November 12, 2013

RE: RESPONSE TO WATER USE INSPECTION REPORT – DATED JULY 29th-30th, 2013 – LIC#: 2AM-

MEA0816

Vault

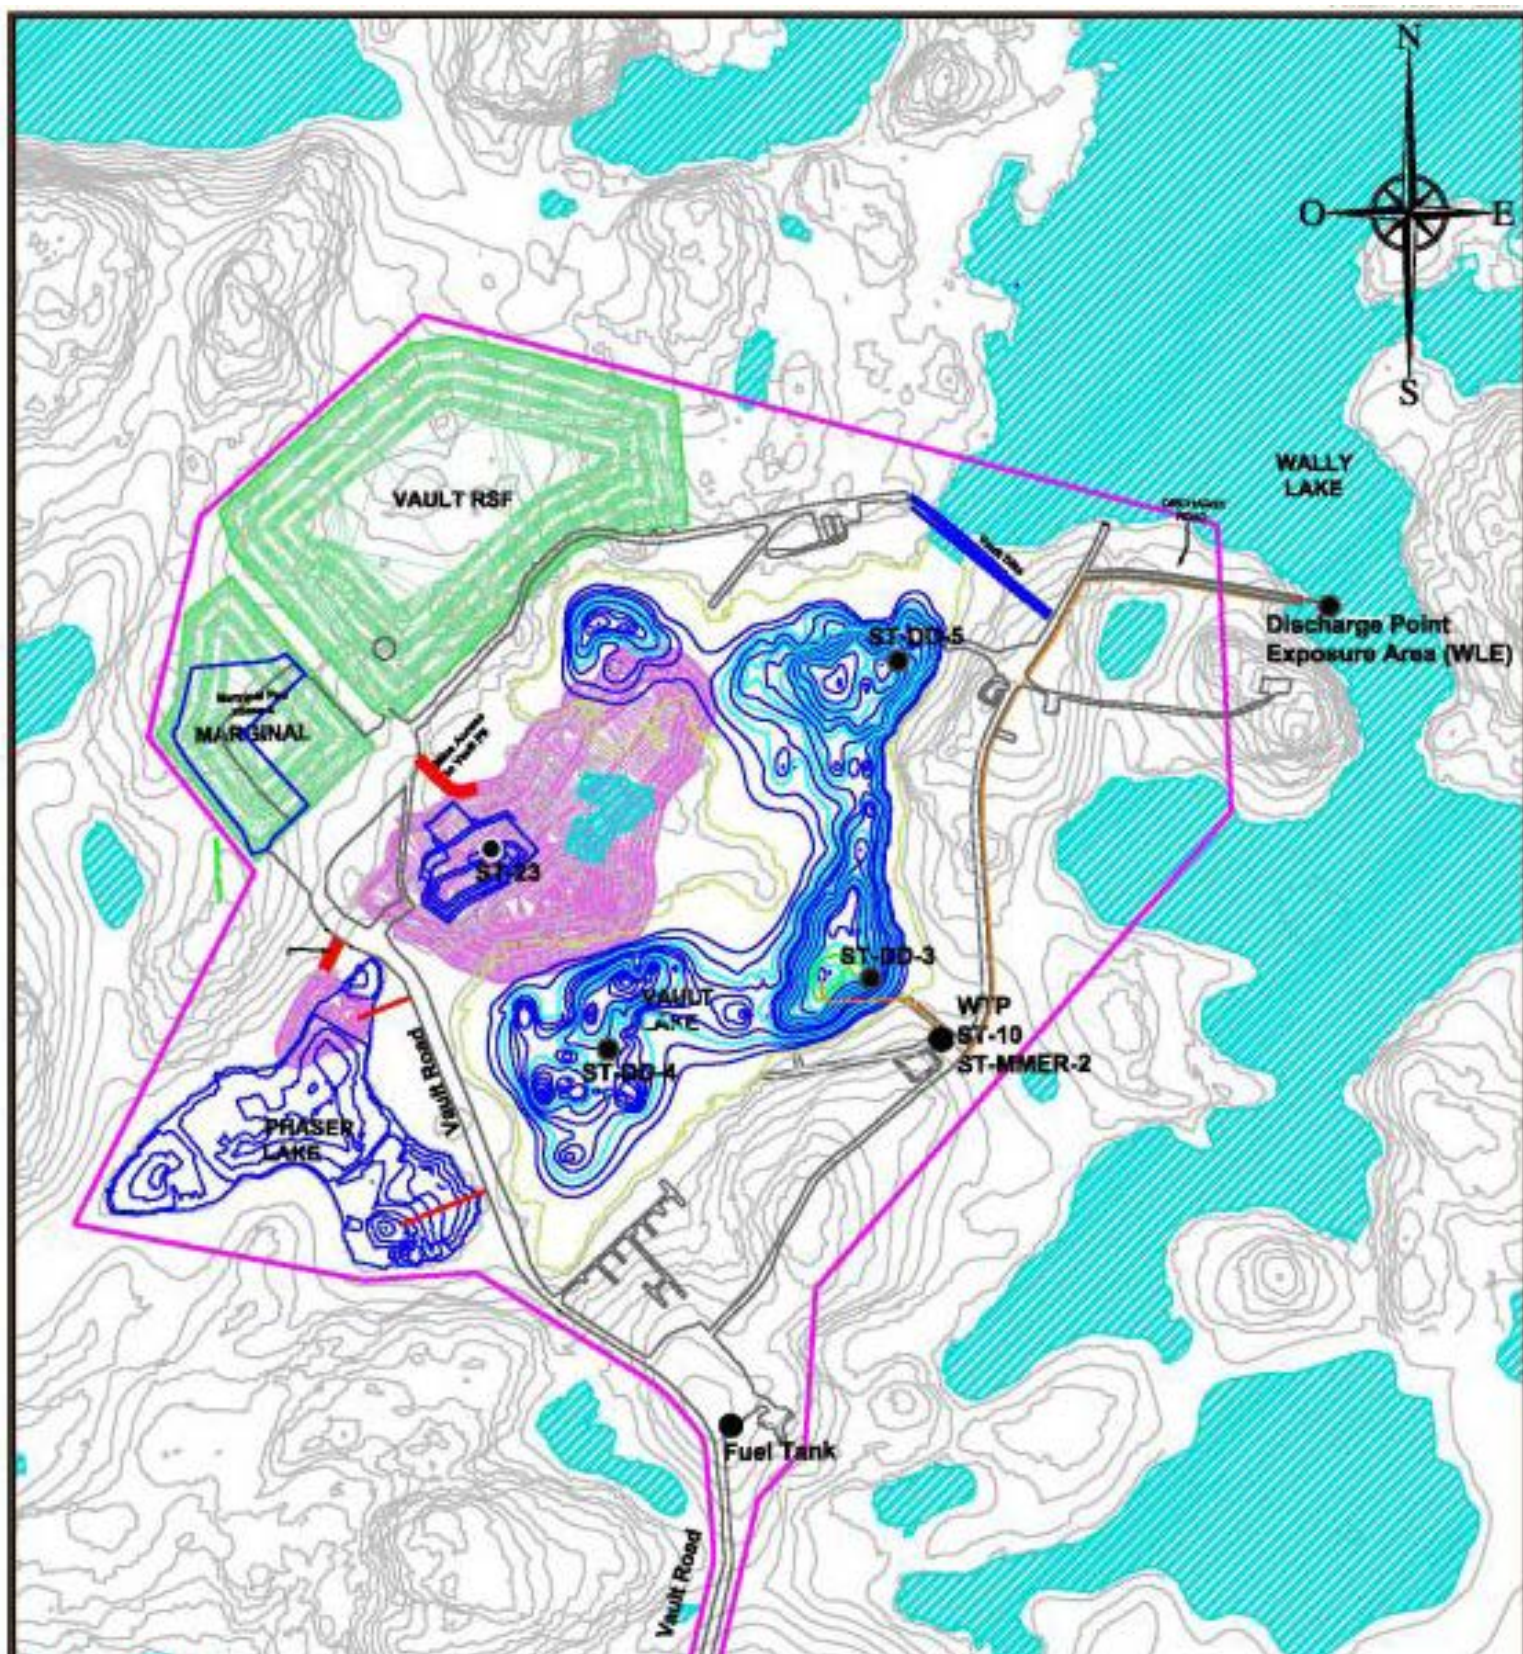
- *Waste rock is being sorted and deposited at the vault waste rock storage facility. The Inspector requested a map detailing the proposed monitoring locations within the Vault deposit area.*

Please find the following map depicting the monitoring locations within the Vault area.
